MANDATORY SERVICE BULLETIN P-2

LANDING GEAR HYDRASORB INSPECTION

SUBJECT: Inspection of landing gear hydrasorb shock struts.

MODELS AFFECTED: Piper PA-25-235 and Piper PA-25-260 Pawnee aircraft with Univair hydrasorb shock struts p/n U486-604-1 as used on the Univair U64052-002 and U64052-003 shock strut assemblies.

Figure 1

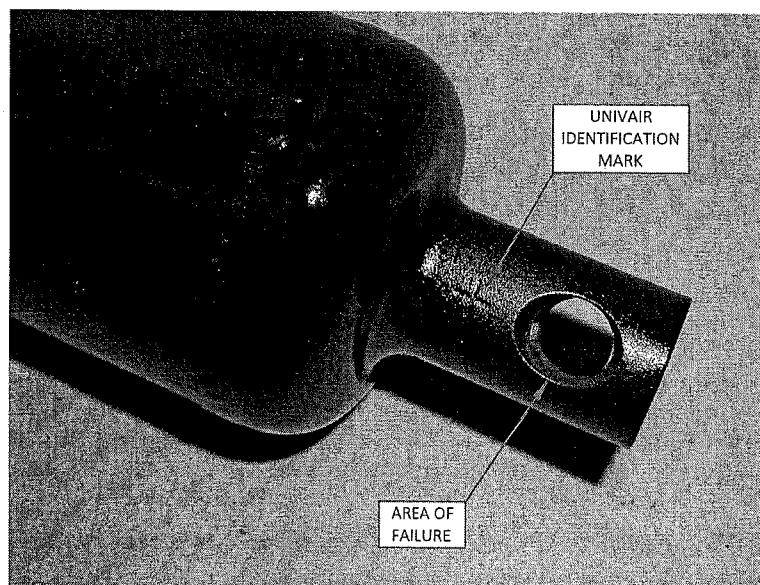
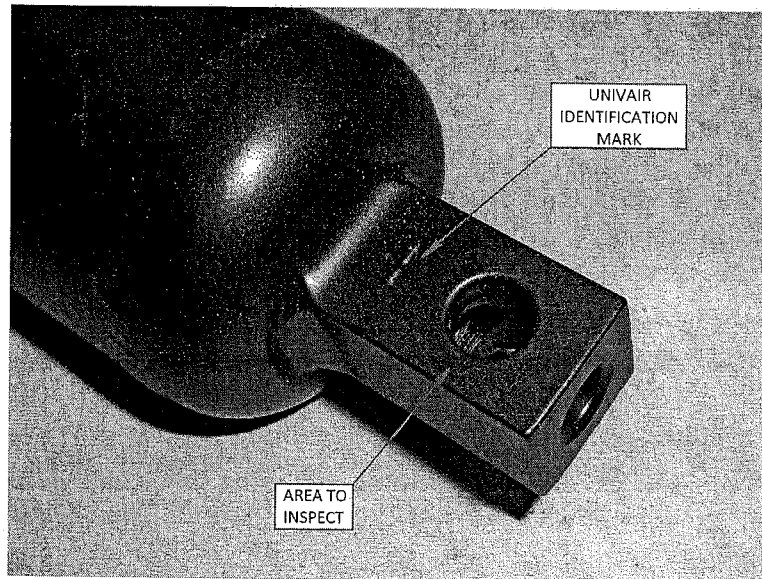
1. Ensure aircraft is situated in a stable configuration, incapable of moving.
2. Raise and support wing to take weight off of the shock strut assembly of the side to be inspected.
3. Remove shock strut assembly from aircraft. Verify that the hydrasorb unit is manufactured by Univair by the crossed-line identification mark as illustrated in figures 1 and 2.
4. Visually inspect lower end fitting for any obvious cracking and/or hole elongation. Also, examine lower end fitting with a dye-penetrant inspection per AC43.13-1A. See figures 1 and 2.

Note: The hydrasorb that failed had an end fitting as in figure 1. Figure 2 is a hydrasorb with a newly designed end fitting.

5. If any hole elongation is found, or if any cracking is found, replace the U486-604-1 hydrasorb unit prior to re-installation of the U64052- series shock strut assembly.
6. Inspect attach hardware and elastic shock cords. Replace as necessary.
7. Installation of the shock strut assembly is the opposite of the removal.
8. Repeat procedures 1 through 7 for the other landing gear.

Contact Univair Aircraft Corporation for availability and pricing of U486-604-1 replacement hydrasorbs incorporating the new style square end fitting.
